# **SERVICE BULLETIN**

M-1132 February 19, 2003

## CYLINDER HEAD TORQUE PROCEDURE UPDATE

Figure 1. Cylinder Head Tightening Sequence

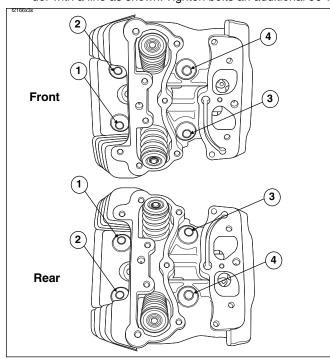
To communicate a new standardized cylinder head torque procedure, which improves clamp force of cylinder heads.

Short head bolts will be installed in the 1 and 2 positions, and long head bolts in the 3 and 4 positions.

- Lightly oil cylinder head bolt threads and shoulders prior to installation with clean H-D 20W50 engine oil.
- See Figure 1. Tighten cylinder head bolts incrementally in the sequence shown, first between 120-144 in-lbs. (13.5-16.2 Nm). Then between 15-17 ft lbs (20.3-23 Nm).
- See Figure 2. Mark cylinder head and head bolt shoulder with a line as shown. Tighten bolts an additional 90°.

- Lightly oil cylinder head bolt threads and shoulders prior to installation with clean H-D 20W50 engine oil.
- 2. See Figure 1. For each cylinder head, start with bolt numbered one, as shown. In increasing numerical sequence (i.e. 1,2,3,4) tighten head bolts in the following steps:

- a. Tighten each head bolt to 96-120 in lbs (11-13 Nm).
- b. Tighten each head bolt to 13-15 ft-lbs (18-20 Nm).
- c. Loosen all head bolts.
- d. Tighten each head bolt to 96-120 in lbs (11-13 Nm).
- e. Tighten each head bolt to 13-15 ft-lbs (18-20 Nm).
- 3. See Figure 2. Mark cylinder head and head bolt shoulder with a line as shown. Tighten bolts an additional 90°.
